Baseline for 149.4.2.4

Start from 97.4.2.4

97149.4.2.4 PHY Control function

Figure 149-16 – PHY Control state diagram

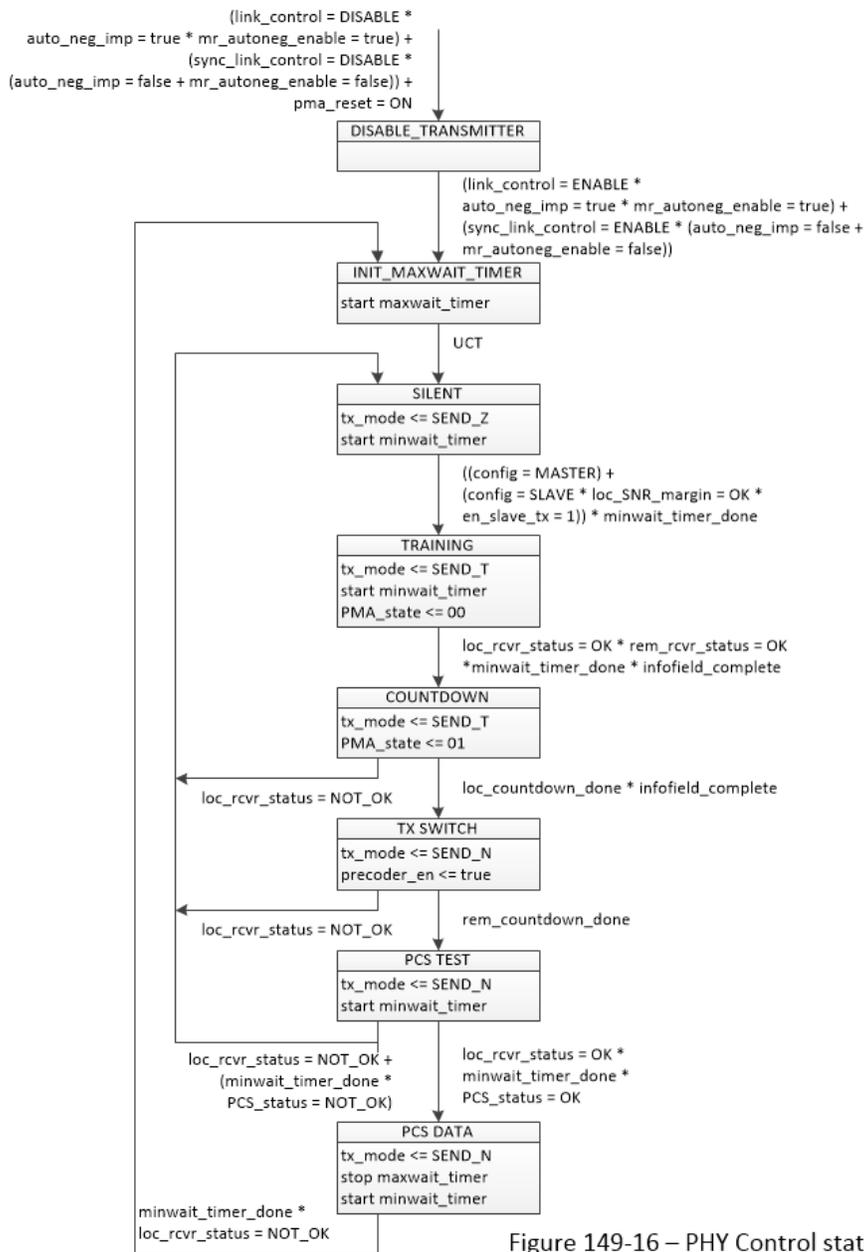
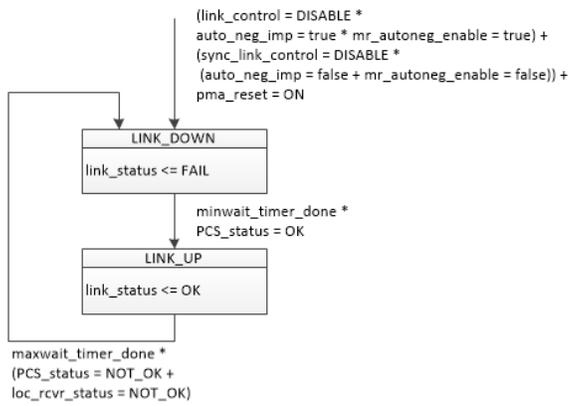
[NOTE: Need to redefine “rem_countdown_done” to be based on implicit counter values, instead of checking last InfoField.]

[NOTE: Need to define “PCS_status” based on Clause 55.]
